This Transmittal Sheet applies to the Revision 07, dated 20110901, of Service Bulletin MXH-35-240

TITLE: OXYGEN – HARNESS ASSEMBLY - INSPECTION FOR POTENTIAL DEFECTIVE COMPONENT

MXH-35-240

Figure 2 – “I” Letter Position

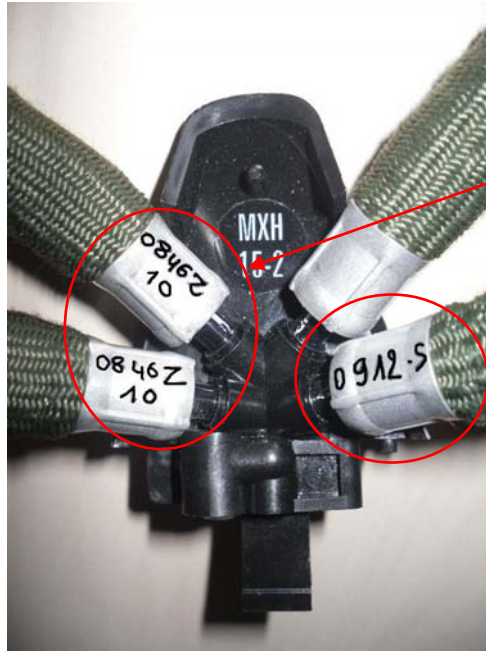
With indelible ink or an electric pen, write visibly the SB accomplishment by adding of letter "I" (Inspected) on the bushing of inflatable harness (See Figure 2).

The marking shall be visible once the harness has been re-installed on the mask.

Figure 3 – Manufacturing Date Explanation & Batch Number Position

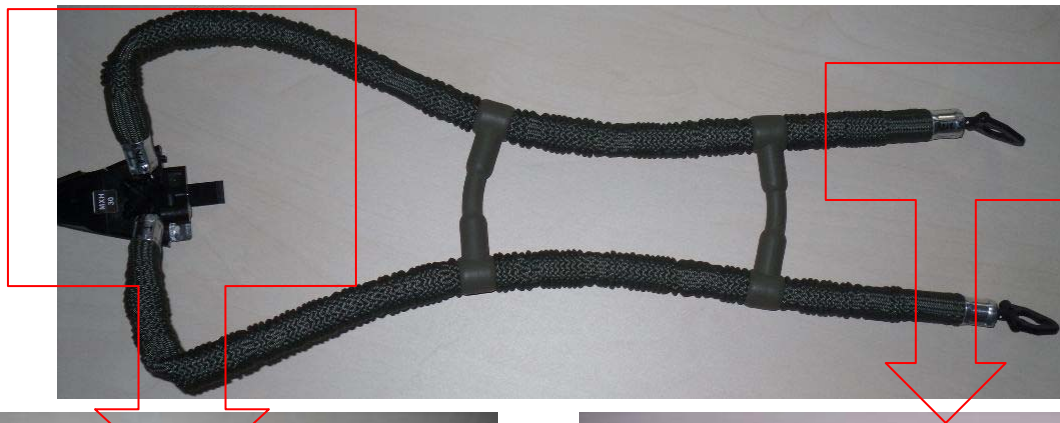
(1) Inspect the batch number (See Figure 3) of the inflatable harness:

- If the batch number is found in the list of Appendix I, forward the defective inflatable harness to the appropriate Zodiac Services maintenance facility for replacement of the inflatable harness.
